**GOVERNMENT OF INDIA
MINISTRY OF RAILWAYS
RESEARCH DESIGNS & STANDARDS ORGANISATION**

MODIFICATION SHEET NO.RDSO/WAM4/197

Provision of EMU type after-cooler on air brake locomotives.

WAG4A, WAG-5, WAG-7, WAP-1, WAP-3 and WAP-4

FOR WAG 5 CLASS LOCOMOTIVES

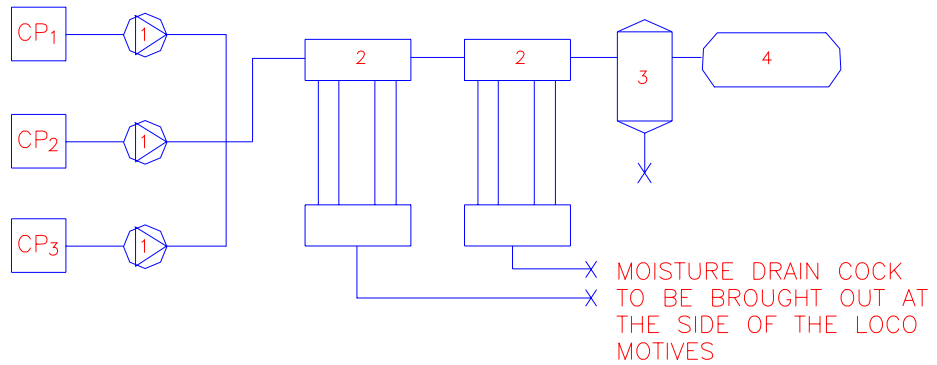
6.0 Details of modification for WAG5 and WAG7 locomotives :

- 6.1 Remove the existing after-coolers and its mounting brackets from its present location.
- 6.2 4 mounting angles 75x75x10 thick are to be welded at the location as shown in CLW drawing No.06/2/34/23.
- 6.3 Mount each EMU after-coolers with the help of 4 Nos. Bolts M-12x60 and nuts (M-12) as per CLW drawing No.6/2/34/23.
- 6.4 Connect the pneumatic circuit as per RDSO Drg. No. SK. EL. 4406.
- 6.5 The drain cock on the after cooler may be brought out so that it can be operated periodically by the running staff.

FOR WAG 7 & WAP CLASS LOCOMOTIVES

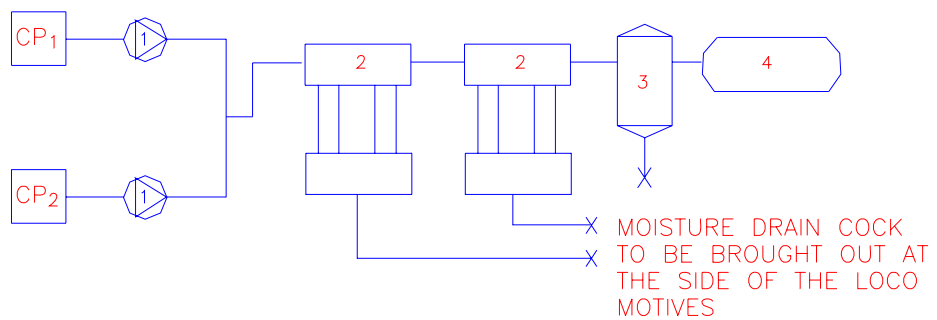
7.0 Details of modification for WAP class of locomotives :

- 7.1 Remove the existing after-cooler and its mounting brackets from its present location.
- 7.2 Supporting brackets are to be welded as per CLW drawing No.03/1/34/50 Alt (1)
- 7.3 Mount both EMU after coolers with 4 nos. bolt and nuts as shown in CLW drawing No.03/1/34/50 Alt(1).
- 7.4 Connect the Pneumatic circuit as per RDSO Drg. No. SK. EL.-4406.
- 7.5 The drain cock on the after-cooler may brought out so that it can be operated periodically by the running staff.
